## Meeting Agenda Plat Committee

Monday, October 25, 2021

1. [KPB-3657](#) Causeway Subdivision 2021 Replat  
KPB File 2021-138

2. [KPB-3658](#) Right-of-Way Acquisition Seward Airport Improvements  
KPB File 2021-047

DRAWN BY: KHE DATE: 2/25/21 SCALE: 1" = 500'  
CHECKED: COR DATE: 2/25/21 SHEET 1 OF 5

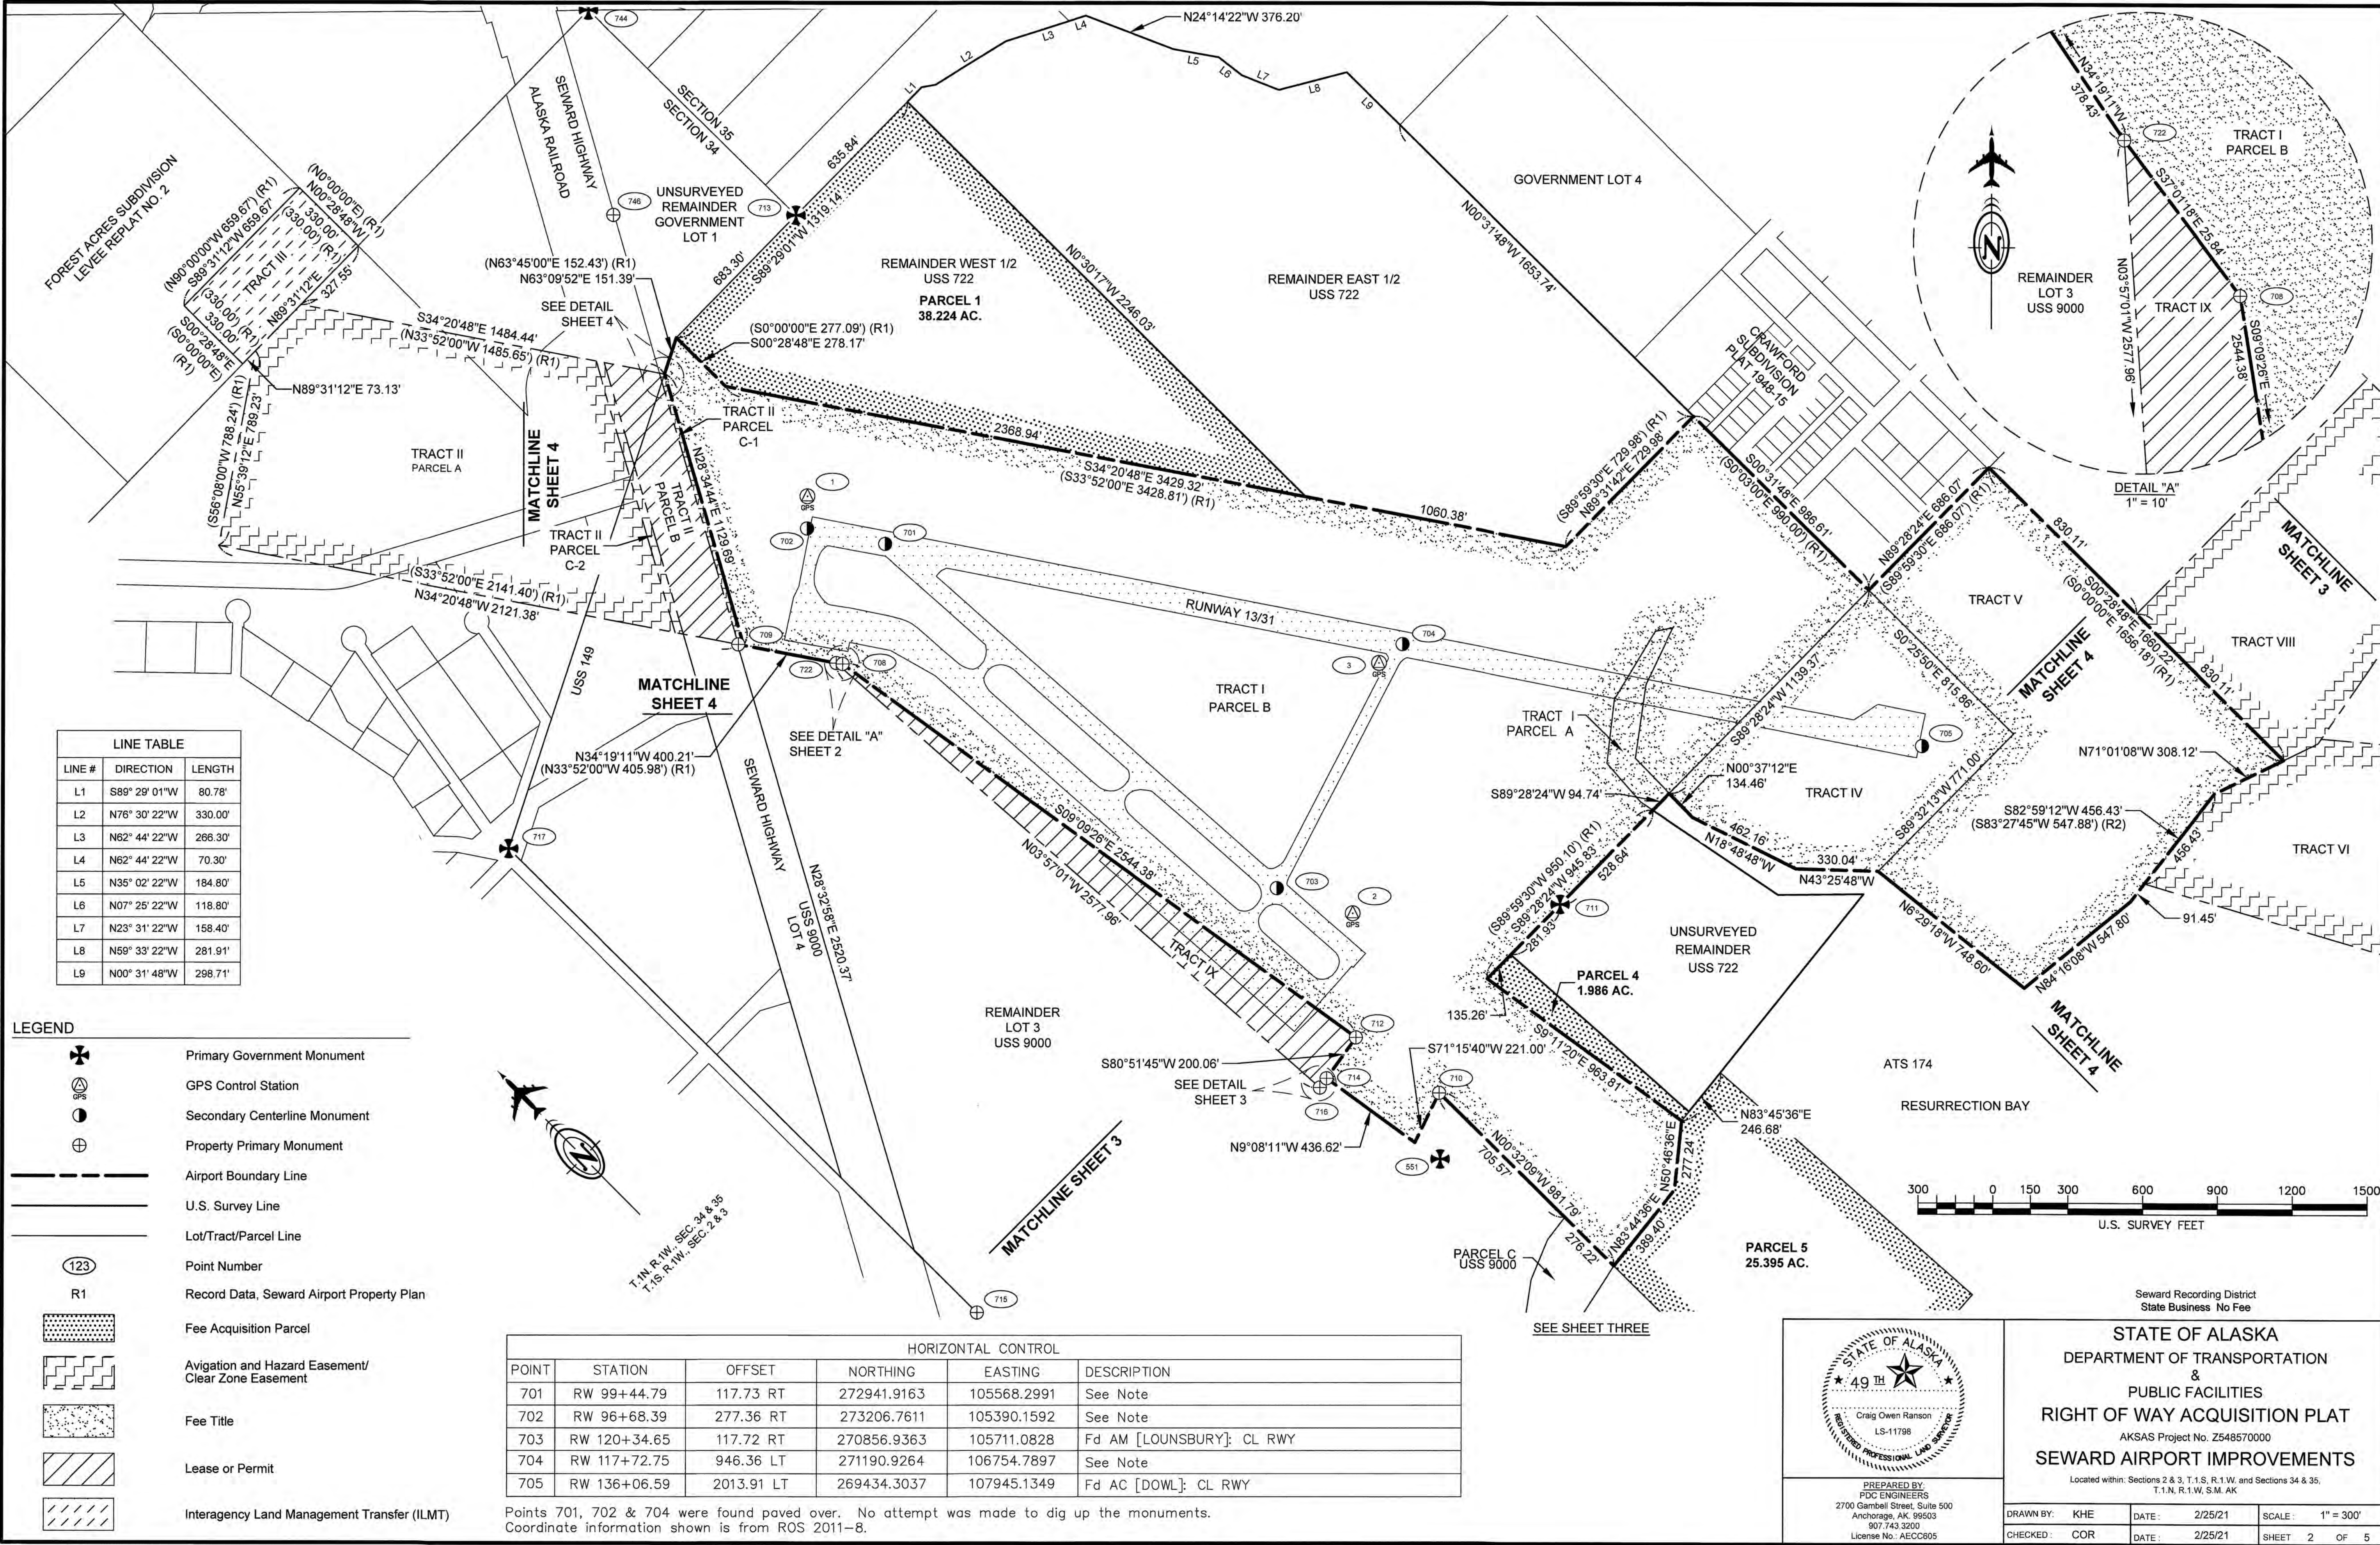
- Within Tract D, below the W1/16 monument, there is a random line. Remove the line or provide information regarding its meaning.
- Provide a Tract label and acreage for Tract C. this may need to be located off the parcel with a leader pointing to the tract.

*Sheet 1 – Add a plat note that the subdivision is within the Chugach National Forest Boundary.*

SHEET 2 OF 5

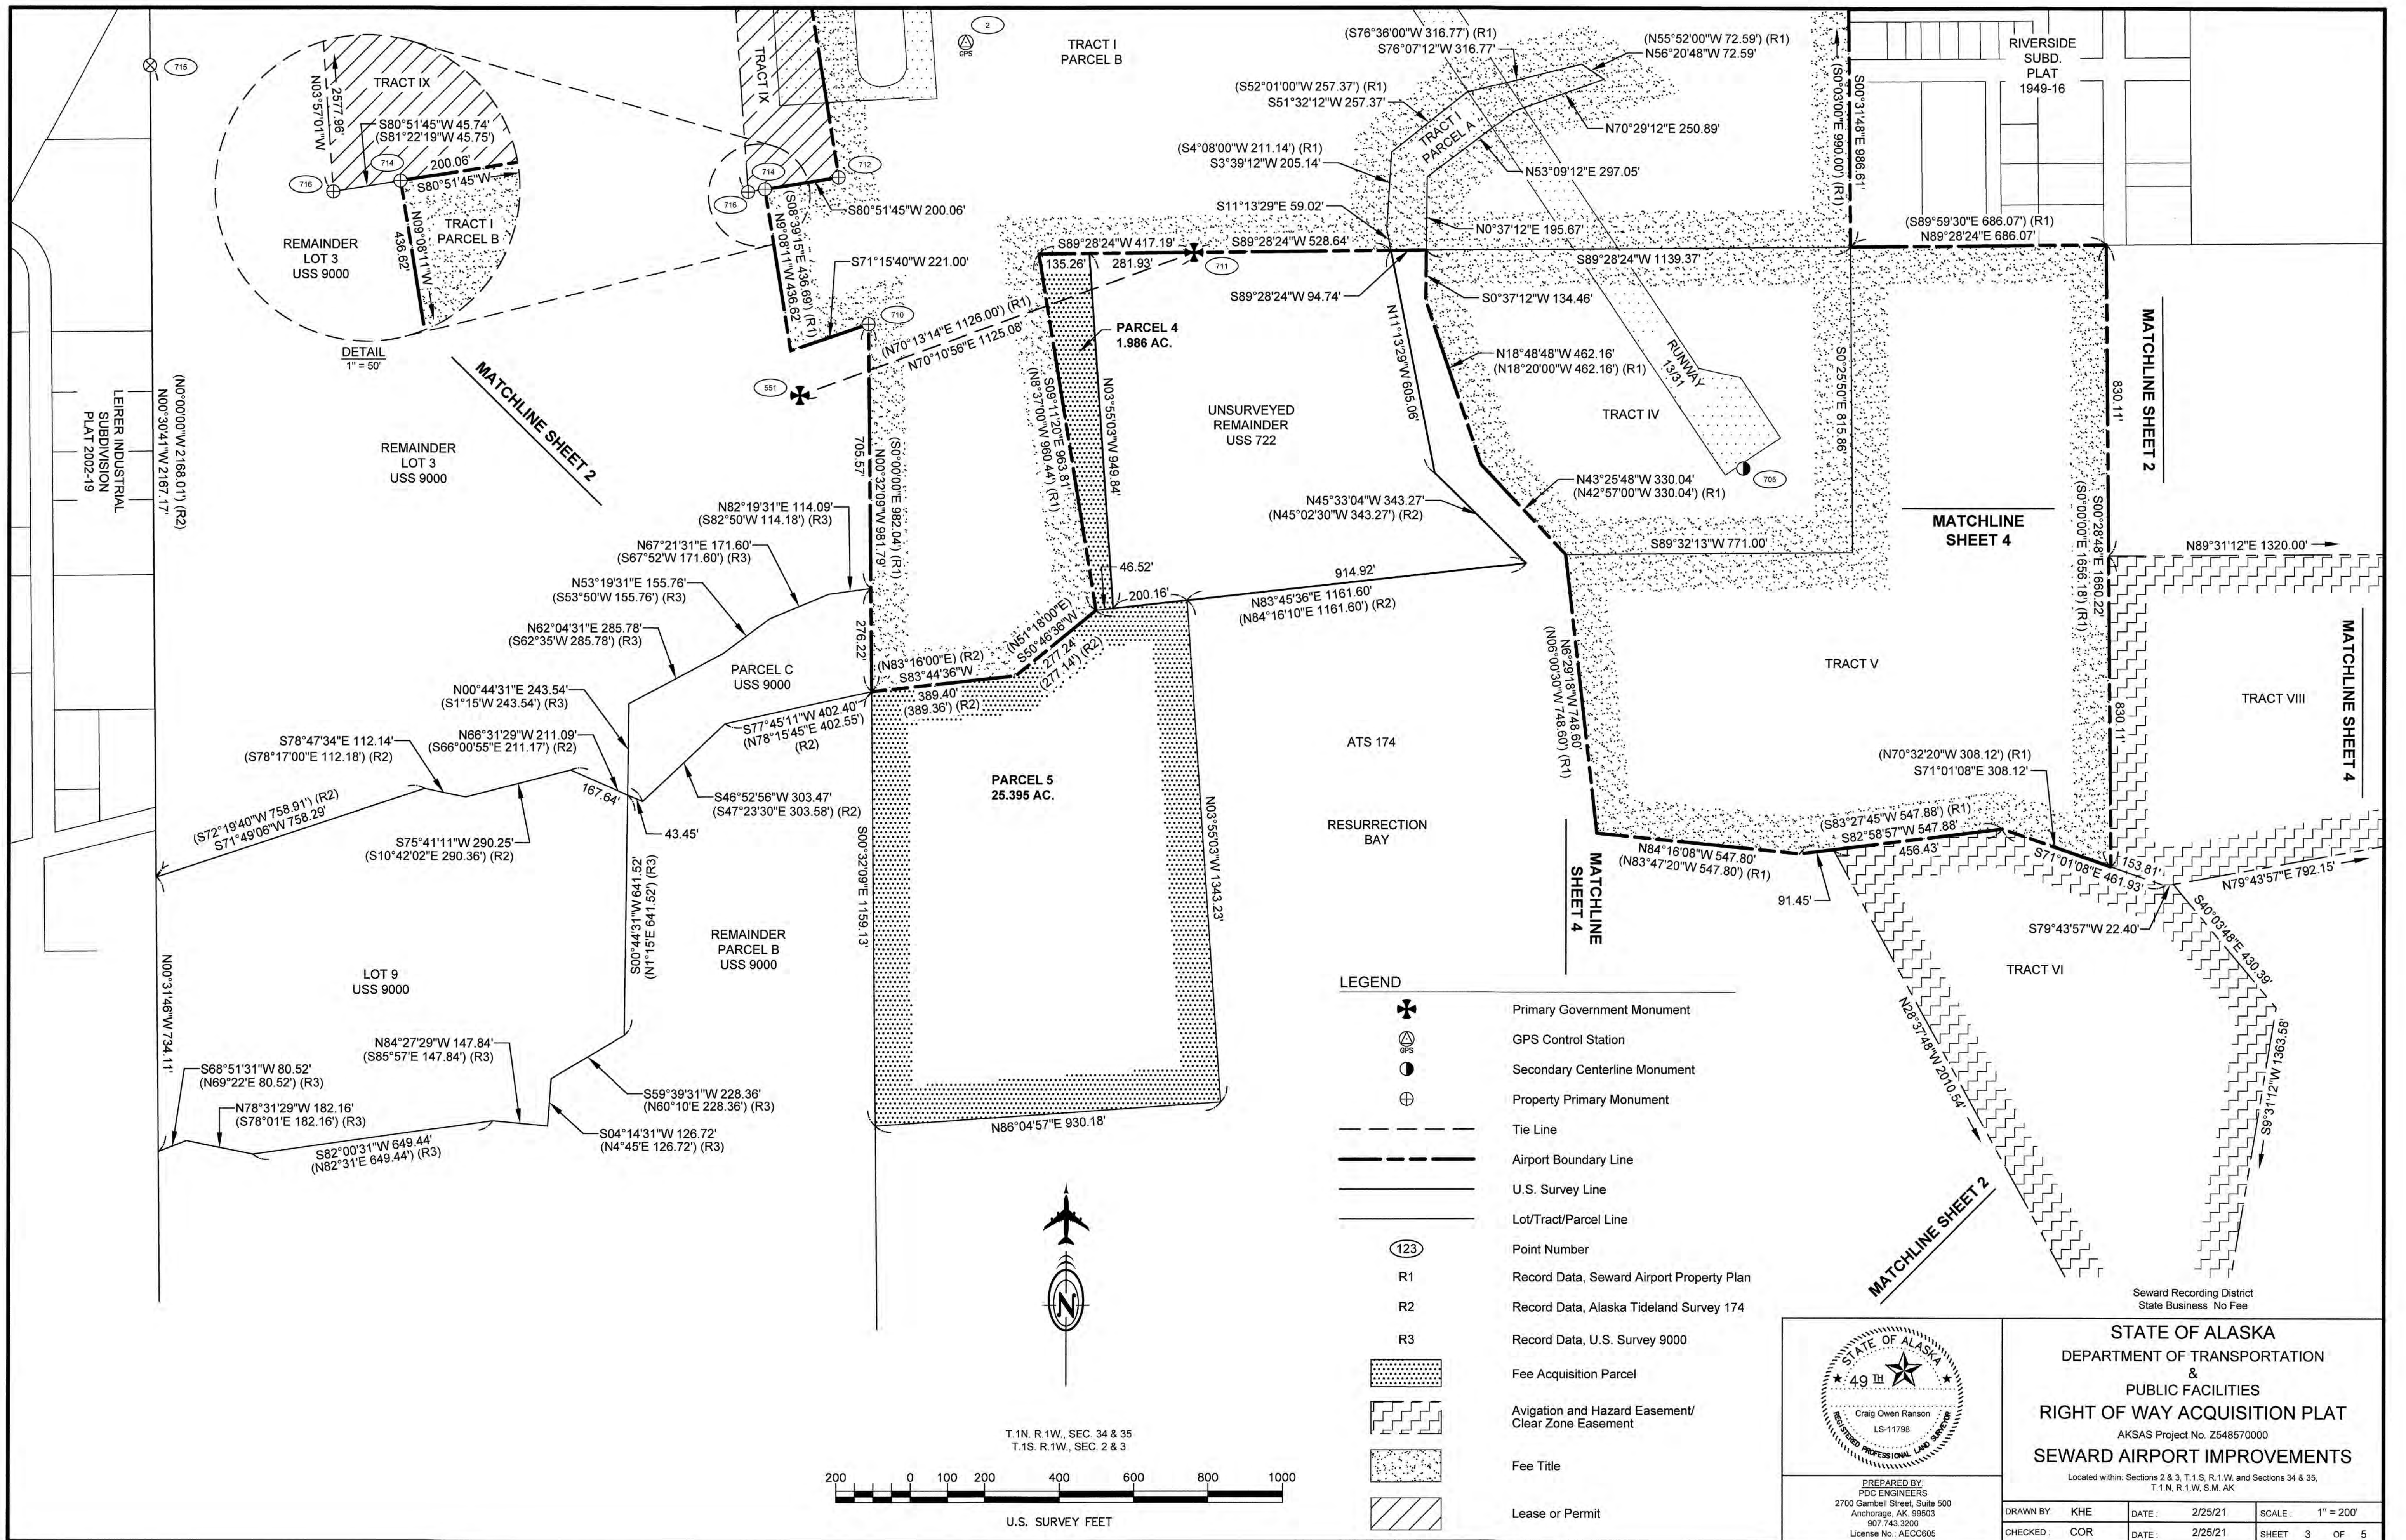
**Utility Easements** A 100 foot easement has been granted to Chugach Electric and is depicted on the plat within Tract D (as shown on sheet 2). Sheet 5 depicts a 20 foot wide utility easement (as shown on sheet 5) that provides access to Tract A of ASLS 2000-01, a tract designated for communications.
